Z-39 (2013)

Views at Vingings Ridge
A MASTER PLANNED TOWNHOME DEVELOPMENT
Pulte Homes
2415 Northwind Parkway
Suwanee, Georgia 30099
Phone: 678-245-1200 FAX: 678-245-1208

REZONING SITE PLAN

PETITION NO: Z-39

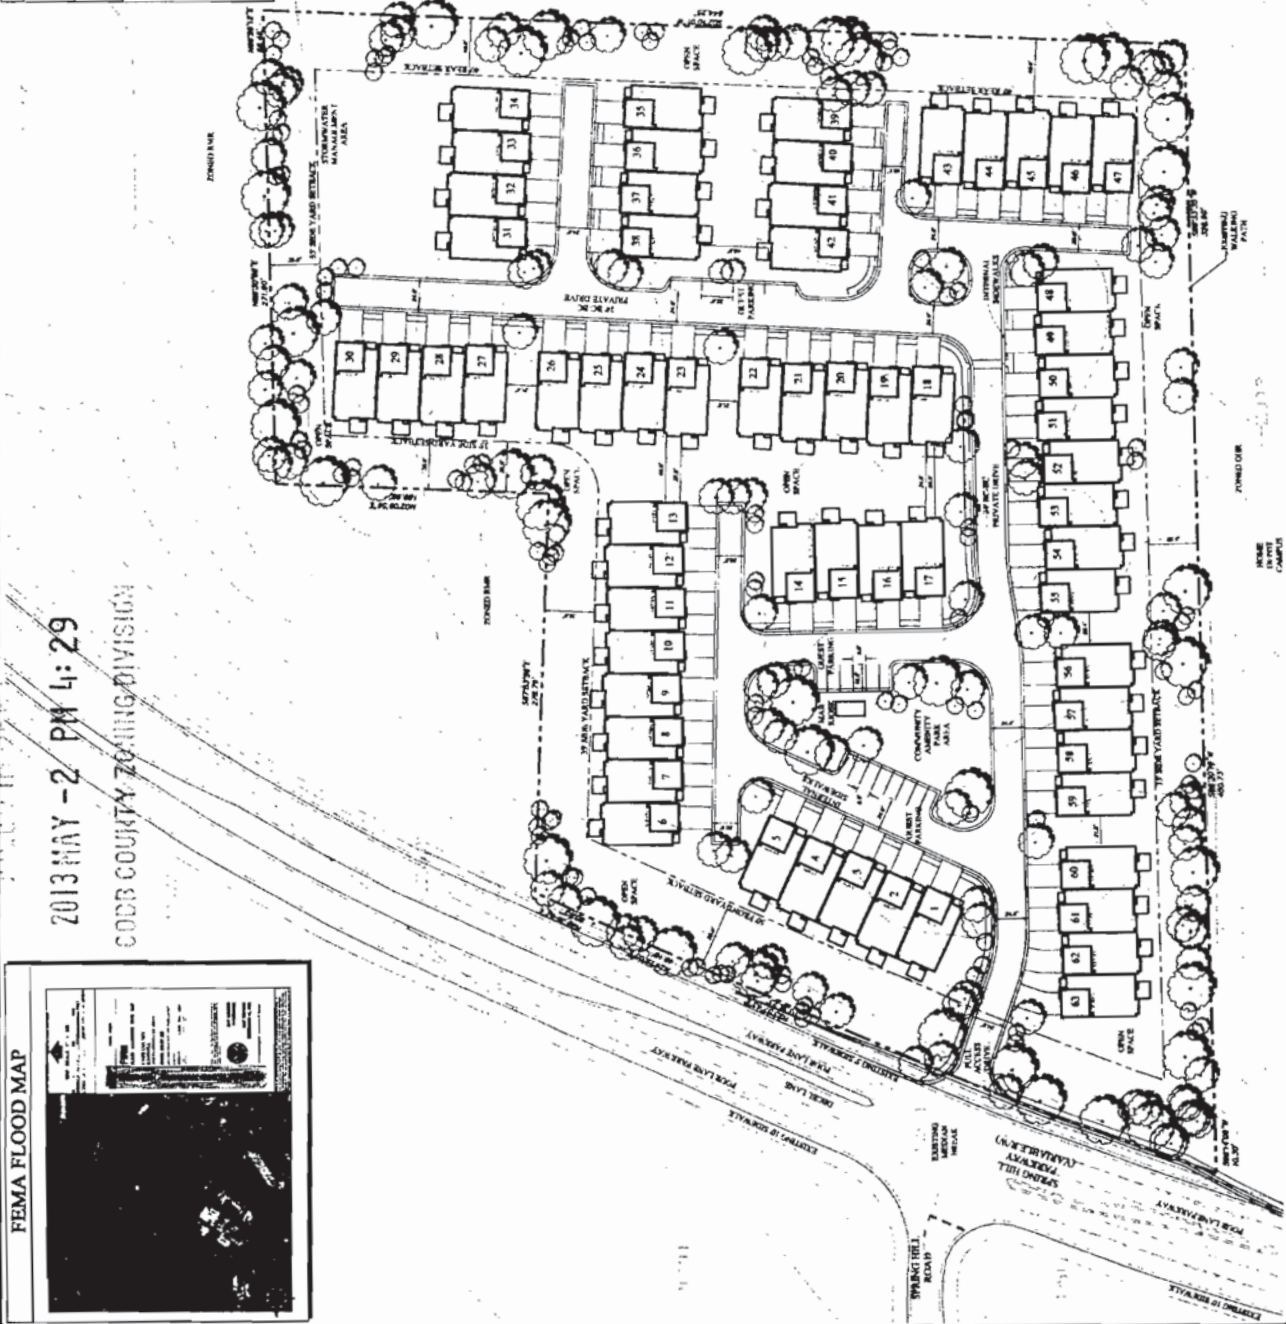
When projects contemplate less than 20 foot separation between units, guest parking shall be provided or the streets shall be labeled as a fire lane.

- Provide comprehensive hydrology/stormwater controls to include development of out parcels.
- Submit all proposed site improvements to Plan Review.
- Any **spring activity** uncovered must be addressed by a qualified geotechnical engineer (PE).
- Structural fill _____ must be placed under the direction of a qualified registered Georgia geotechnical engineer (PE).
- Existing facility.
- Project must comply with the Water Quality requirements of the CWA-NPDES-NPS Permit and County Water Quality Ordinance.
- Water Quality/Quantity contributions of the existing lake/pond on site must be continued as baseline conditions into proposed project.
- Calculate and provide % impervious of project site.
- Revisit design; reduce pavement area to reduce runoff and pollution.

- No Stormwater controls shown _____
- Copy of survey is not current – Additional comments may be forthcoming when current site conditions are exposed.
- No site improvements showing on exhibit.

1. This parcel is located east of Spring Hill Parkway and is bounded by a Post Apartments Development to the north and east and The Home Depot Headquarters to the south. The site is fairly heavily wooded with slopes ranging from approximately 10 to 25%. The parcel is dominated by a central ridge with approximately half of the site draining the northeast to an existing culvert within the Post Apartment complex and the other half draining to the southeast into the Home Depot Master Stormwater Management Facility.
2. Unless a significant portion of the site can be diverted to the north into the proposed stormwater management area an additional pond may be required at or near the southeast corner of the site. This will need to be addressed at Plan Review and may require alteration to the site plan layout.

Recommend curb and gutter along both sides and sidewalk along one side of proposed development roadways.

Recommend a deceleration lane on Spring Hill Parkway for the entrance.
